Planning Permit Application Form

PLN: 2018-458
BLD: _____

Response to Planning Comments PLN 2018-00458

On November 21, 2018 our design team submitted a Design Review Hearing application for a new residence on Sunshine Valley Road in Moss Beach, California, APN: 037156130, on behalf of Fuli Li and Weiguang Xie. On December 21 we received planning comments from Laura Richstone, and on December 26 geotechnical and stormwater/drainage comments from Sherry.

SHEET
 C-2

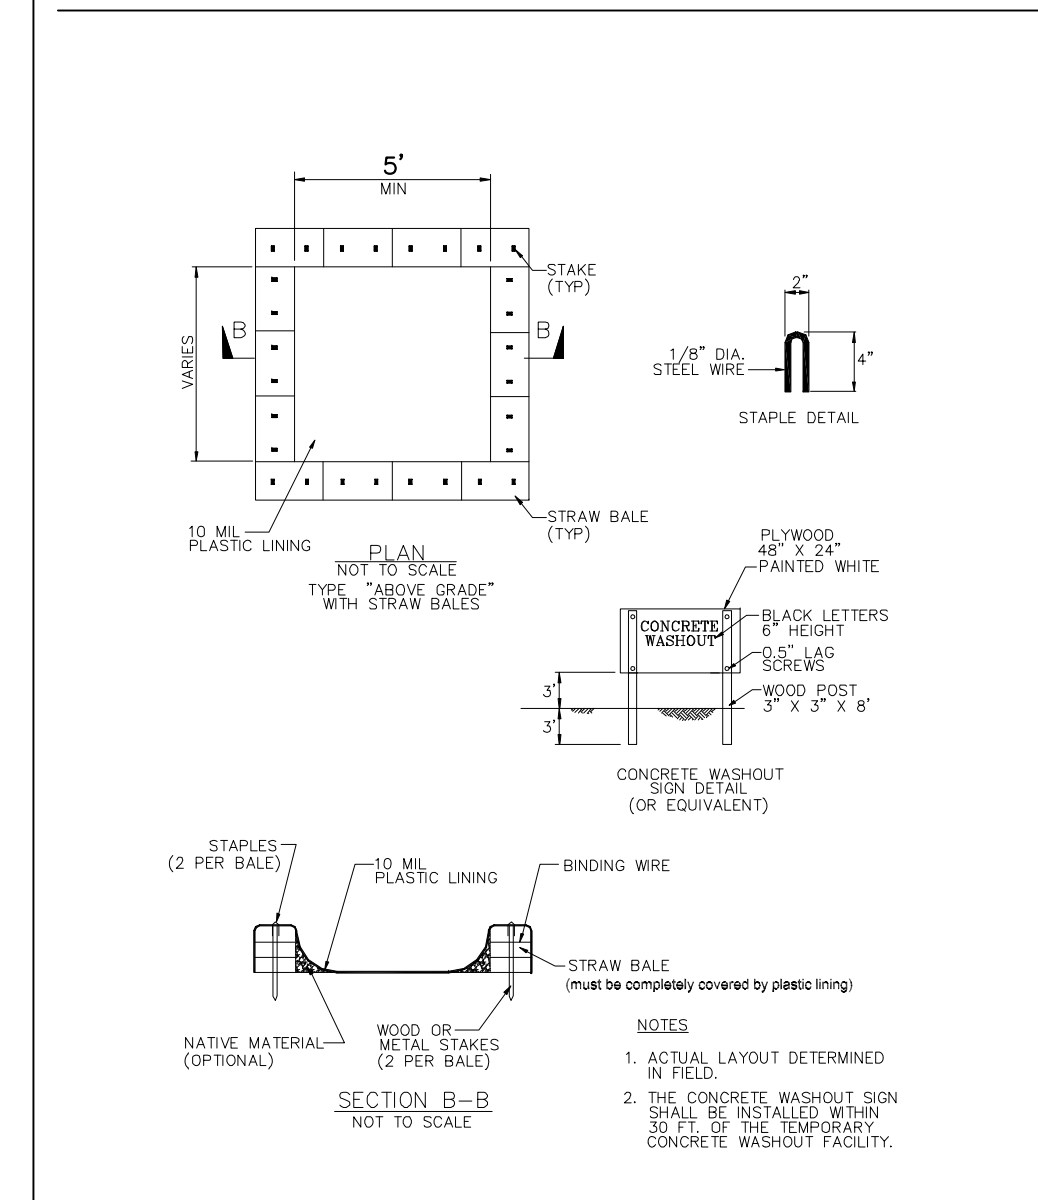
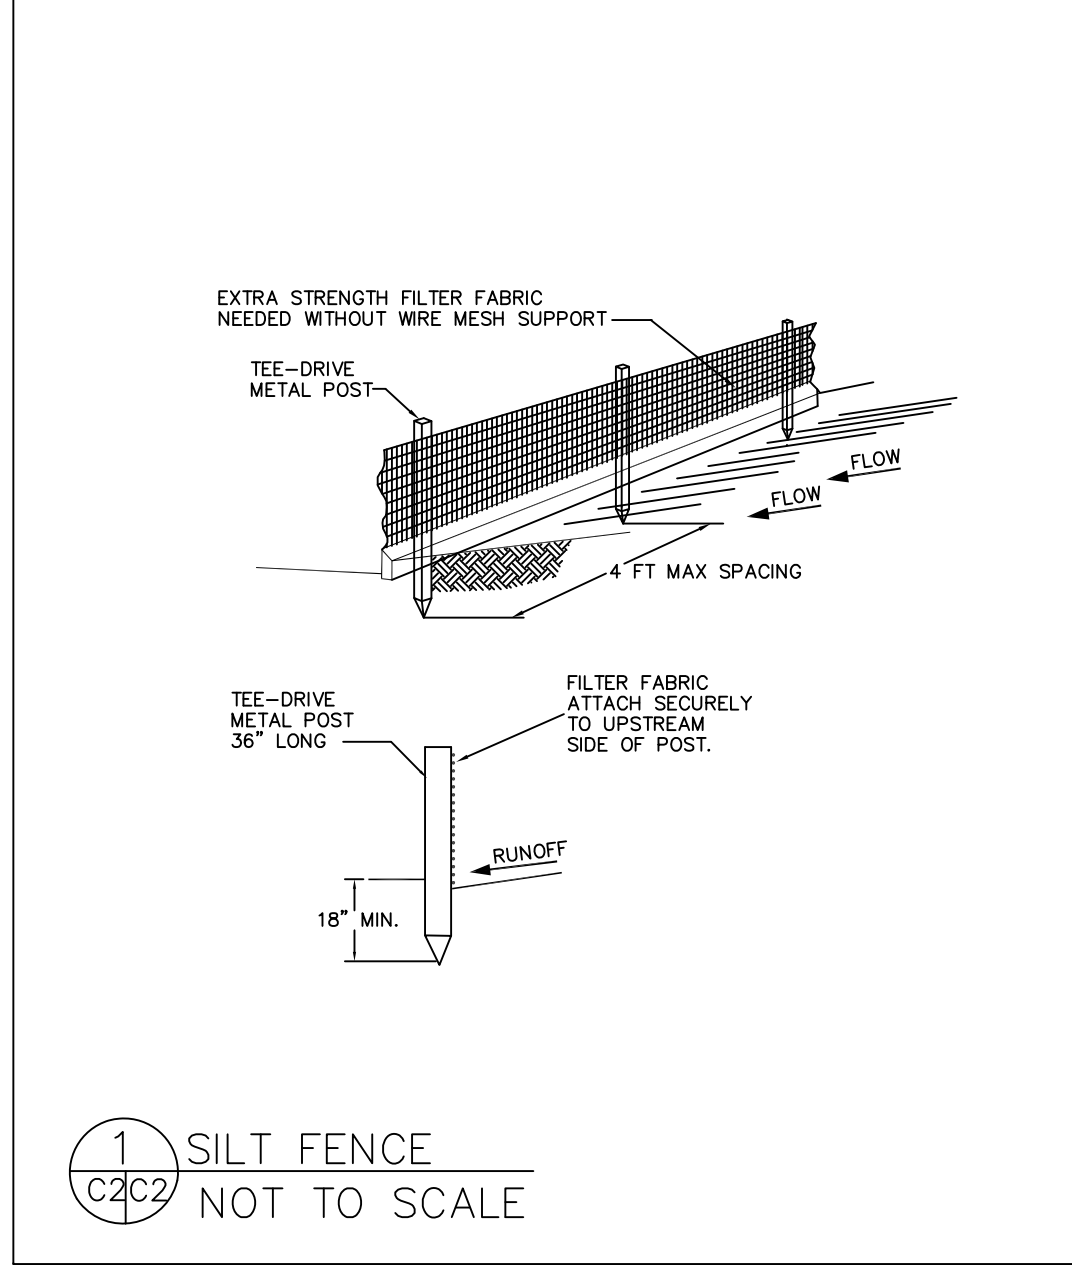
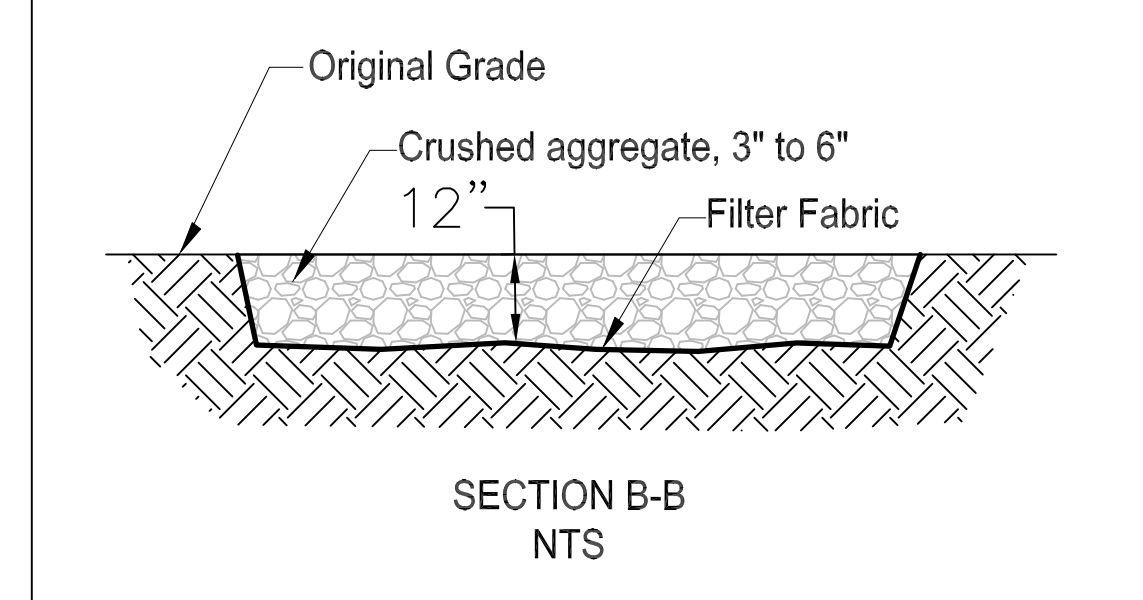
- Please provide an erosion control plan for the construction of the bridge and the house
- The EC plan should be a separate sheet from the grading plan.
 - Show location of equipment storage areas, ec measures, concrete washout etc.
 - The biologist should consult on the EC plan. See comment 9 below.

- (a) Refer to Drawing No. C-2, Erosion Control Plan.
- (b) Refer to Drawing No. C-2, Erosion Control Plan.
 - (i) Location of equipment storage areas, erosion control measures, concrete washout, etc. are shown on the Erosion Control Plan.
 - (ii) SWCA biologist Kristen Outten assisted in preparation of the Erosion Control Plan. Ms. Outten is a Qualified SWPPP Practitioner (QSP) as well as Certified Erosion, Sediment, and Storm Water Inspector (CESSWI).

DRAWING TITLE: **TREE LOCATION**

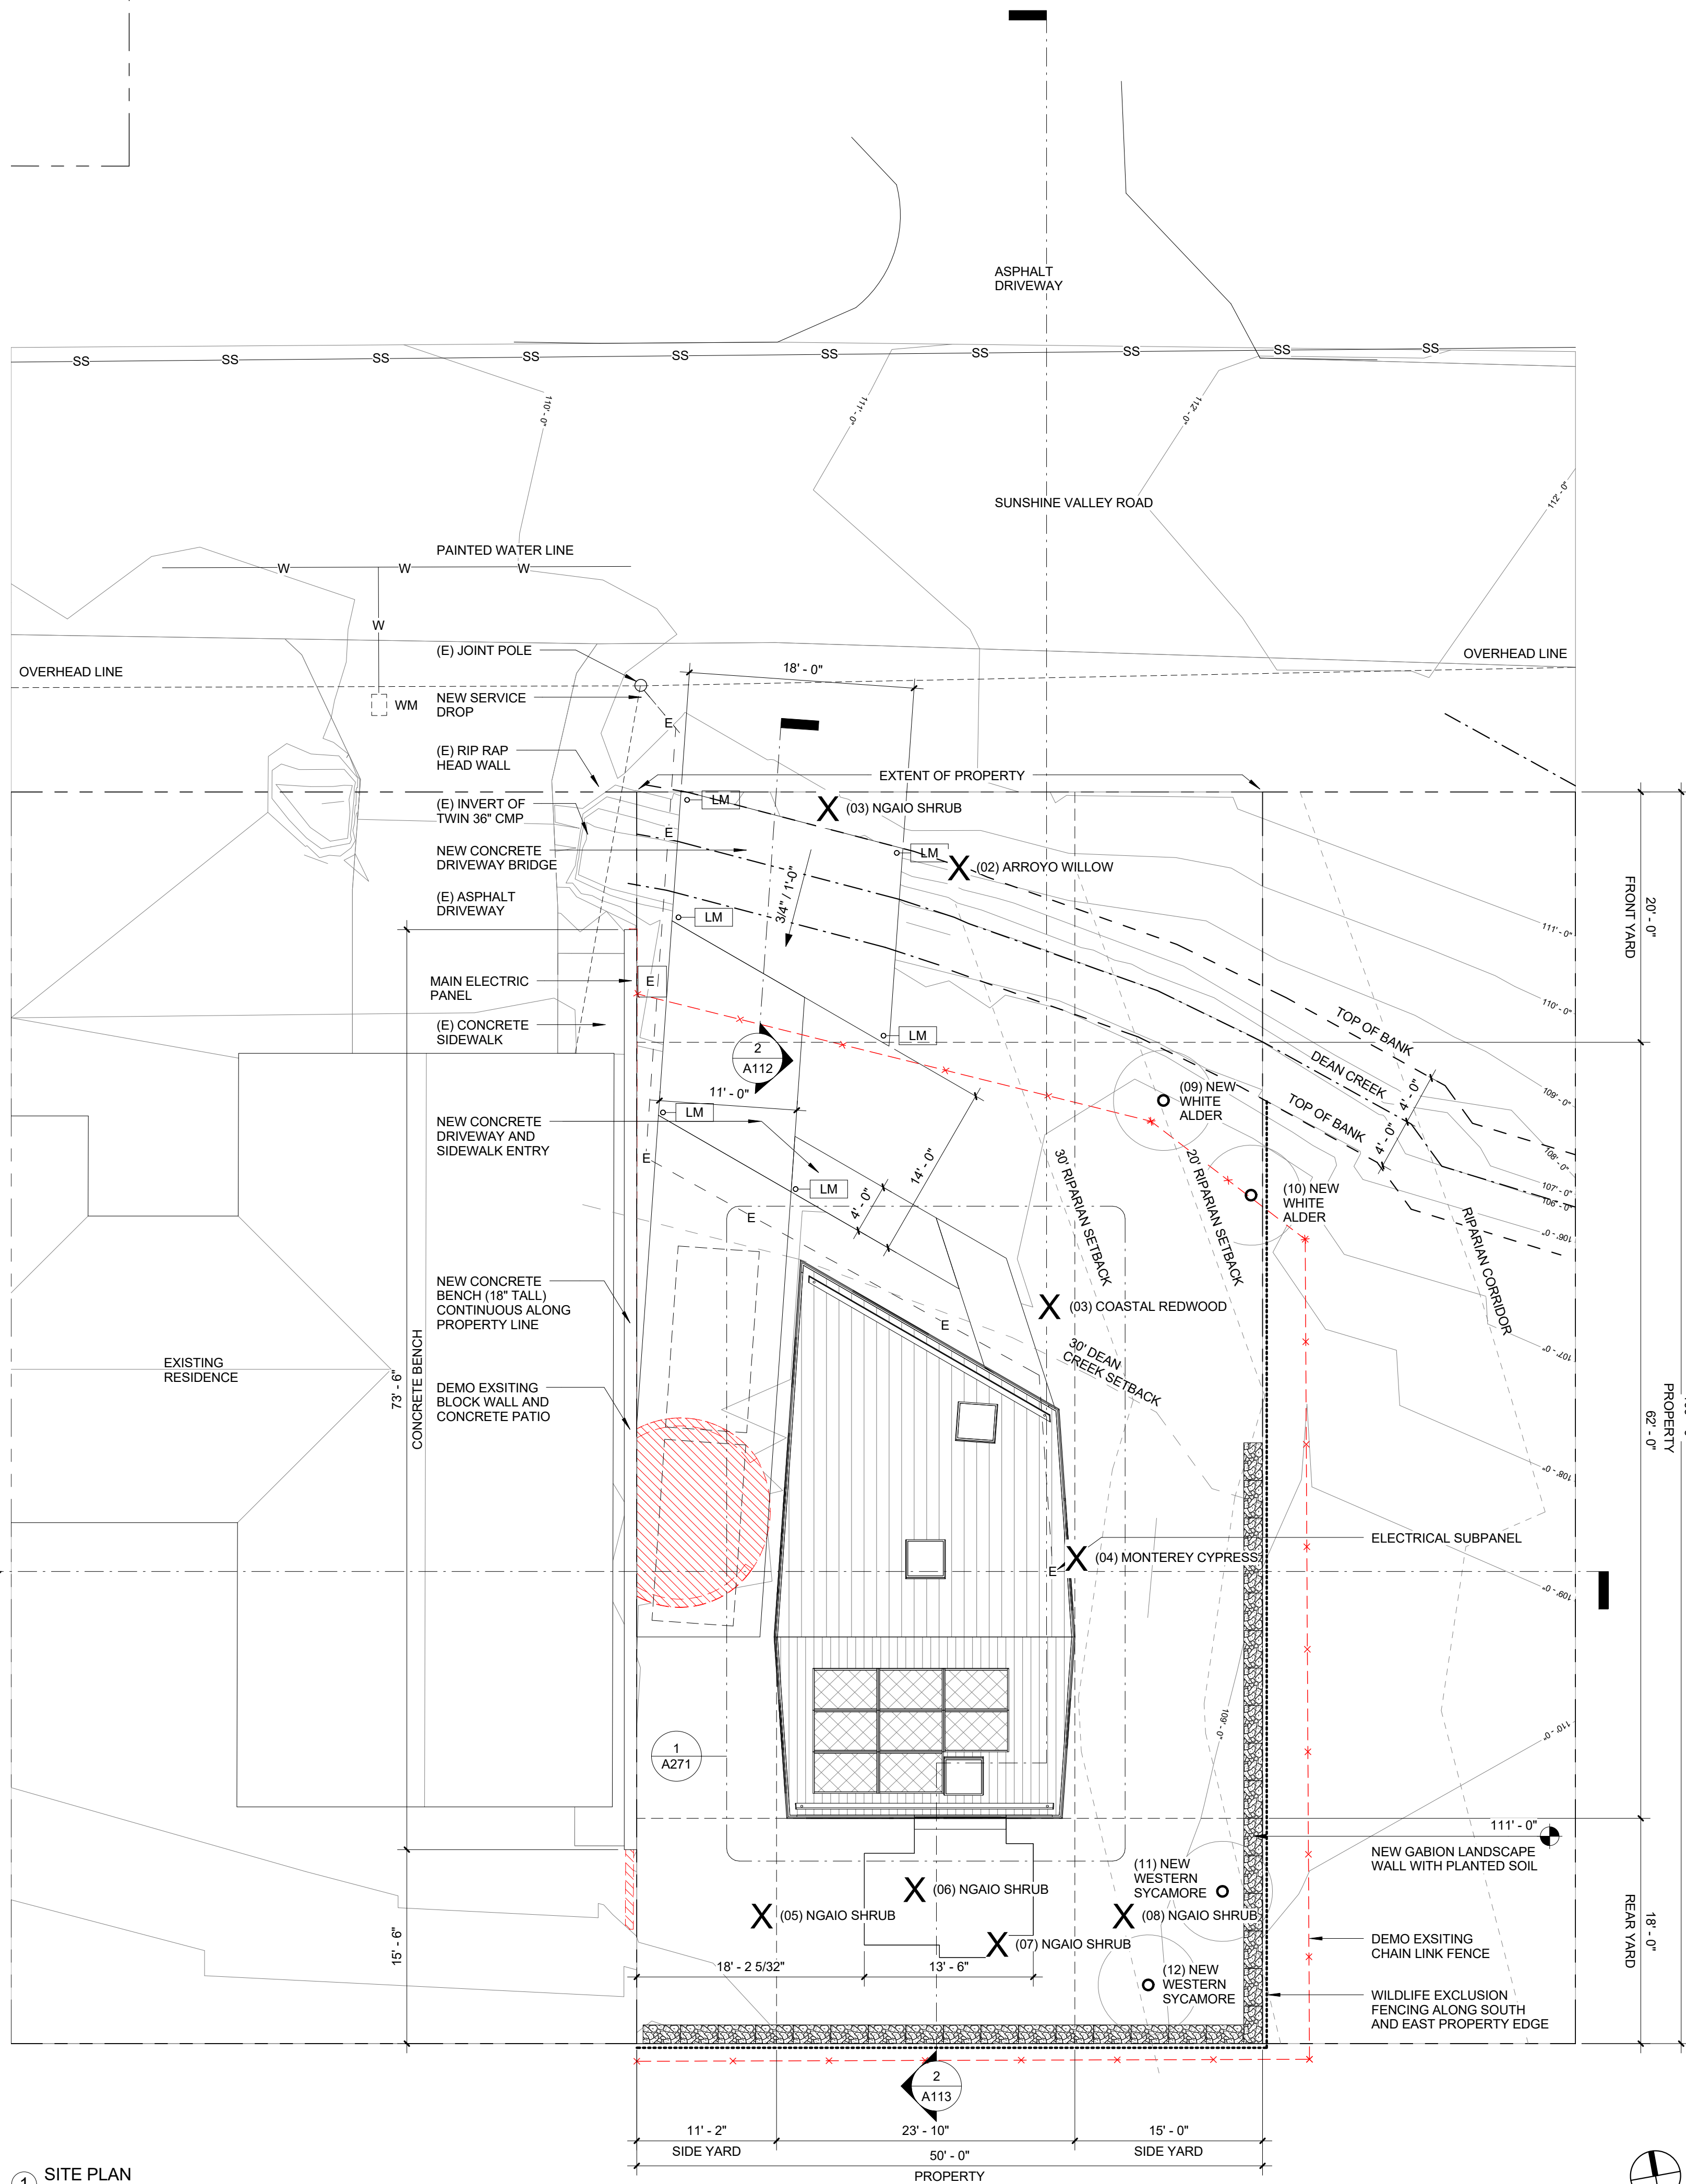
- Revise to include a description of all trees on the property including trees in the right-of-way directly in front of the property (size, health, species etc.) and include recommended tree protection measures for trees to be retained. The report should include a tree inventory.
- Incorporate tree protection measures into a separate tree protection sheet.
- Show recommended location of required tree replantings

Please refer to the documents attached to this document. "Sunshine Valley Residence Tree Report" is a narrative of all trees on site provided by Trees 360 Degrees. "Sunshine Valley Residence Tree Inventory" is a listing of all trees on site provided by Trees 360 Degrees. Recommended new tree planting locations have been provided on the architectural and landscape plans.

(Above) Sequence of site section height studies.

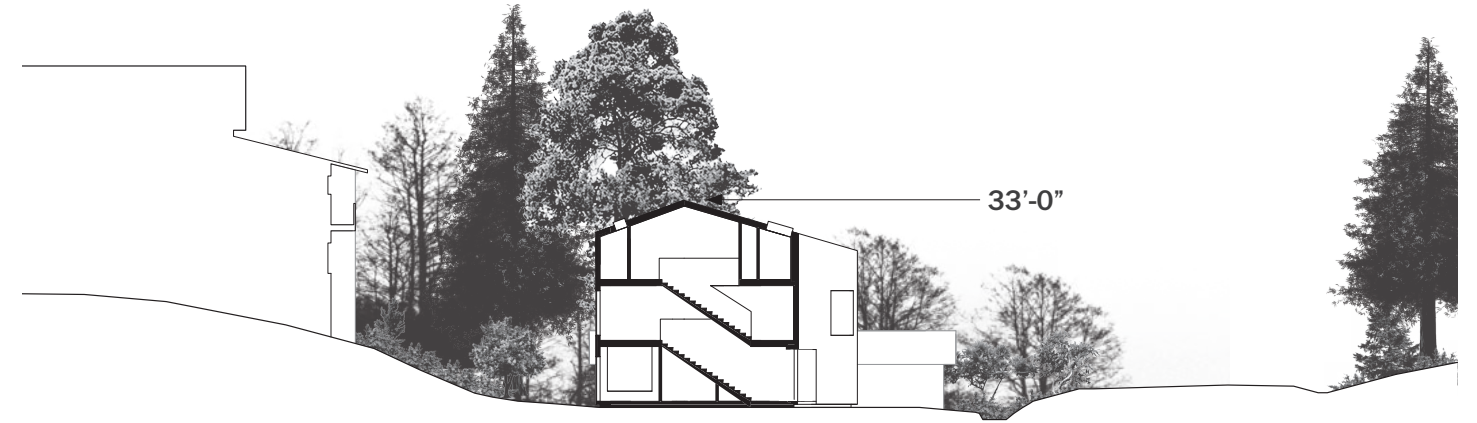
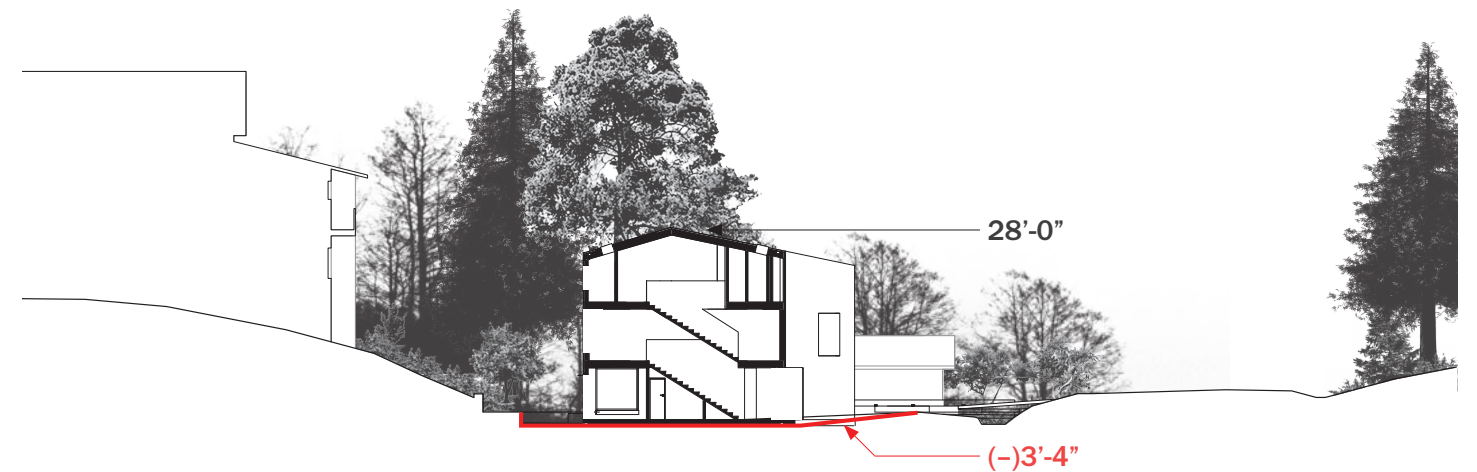
a. The increase in height of 33' is only allowed for parcels with a 30% slope or greater. In addition this height increase is only for the center 40% of the house. Because this lot does not have a significant slope the maximum height for a structure is 28'. Please reduce the height of the building.

(Top right)
Longitudinal section as presented on November 21, 2018 in which only the peak of the house is at 33-feet. The perimeter elevation heights are between 28 and 26-feet.

(Middle right)
After receiving your comments, the house has been reduced as much as possible by: a) reducing the pitch of the roof without creating unliveable top floor rooms, b) reduced the first and second floor heights to 8'-6\", and 3) using a robust laminated veneer lumber joist system to minimize floor depth. Our position on the 8'-6\" height is based on a) lower would affect daylighting thus adding to artificial lighting loads, and b) the house provides radiant heat only, bypassing A/C cooling and any lower height would affect fresh air and bring the trapped heat at the ceiling closer to house occupants. This is the limit of our adjustment without hardship.

(Bottom right)
If the house were required to be reduced to 28-feet (at its peak only), this would cause the ground floor of the house to be carved (or sunken into) the ground plane. This is strongly ill-advised by our geotechnical engineer as it would require a constant sump pump system as well as expensive and robust water-proofing details.

(Above) A112 Architectural Site Plan

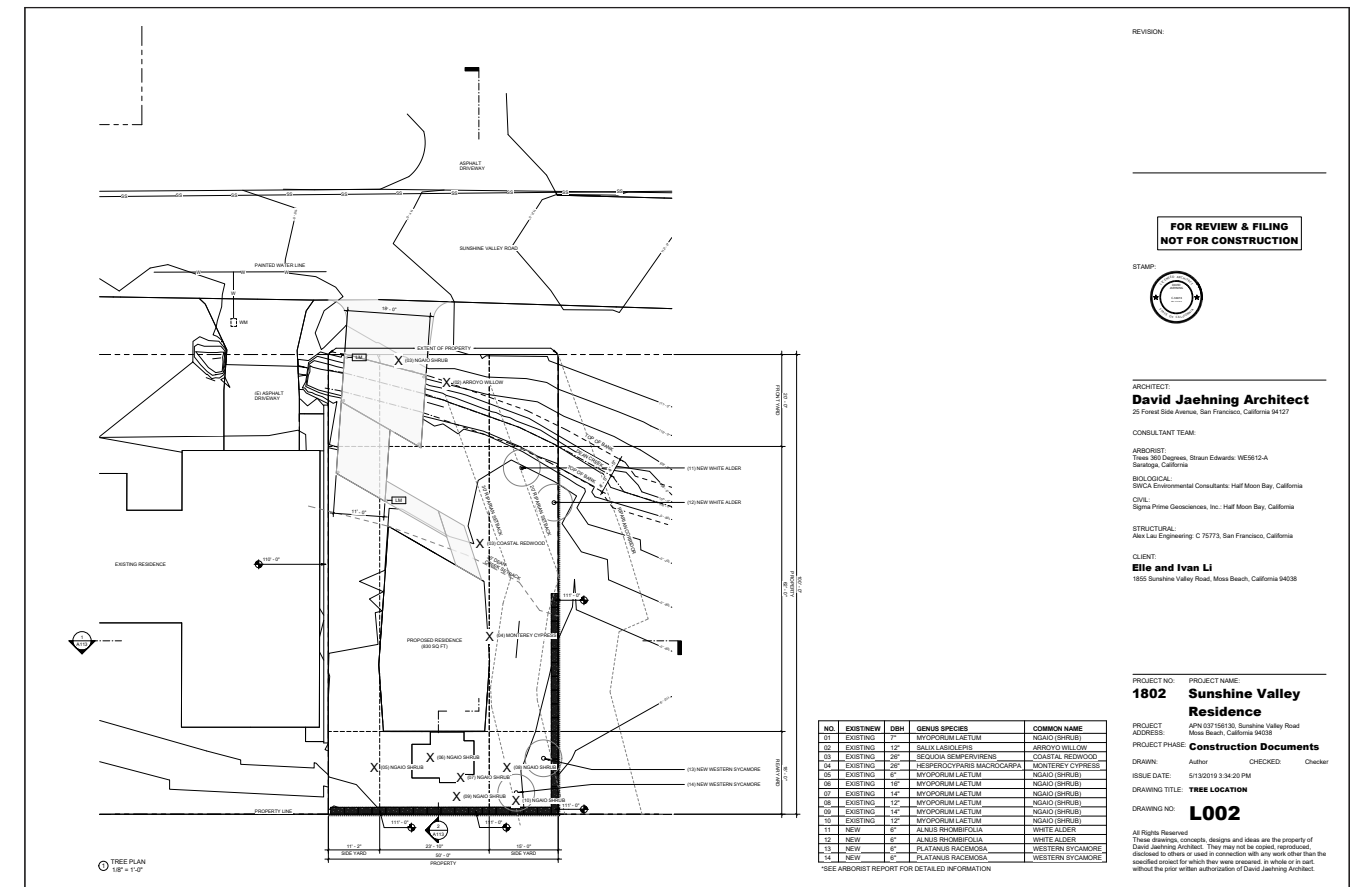
- a. It's hard to tell where the property lines are. Please either bold or specifically call out.
- b. The 30' Dean Creek setback does not scale out to 30'. Portions of the setback only scale to 28' and the house encroaches into the setback. Please move the house out of the creek setback. This will encroach into the rear yard setback but will be covered/ considered under the variance.
- c. Finish drawing the 30' Riparian buffer line.
- i. It looks like the house will encroach into this buffer area when the line is drawn. Move the house outside of the buffer area
- d. Show existing trees on the property and if they will be retained or removed
- i. "X" out trees proposed for removal
- ii. Number the trees per the arborist report
- e. Show location of uncovered parking spaces.

- a. Additional annotations have been added to call out the property lines, b. The previous version followed the setbacks from the (previous biology consultant), The proposed residence has been moved outside the Dean Creek setback, c. The proposed residence has been moved outside the riparian setbacks. d. See updated plan A112 and landscape plans. As per the arborist report, all existing trees to be removed. Trees have been "X" out and labeled per the arborist report, e. uncovered parking spaces are shown dashed on A112.
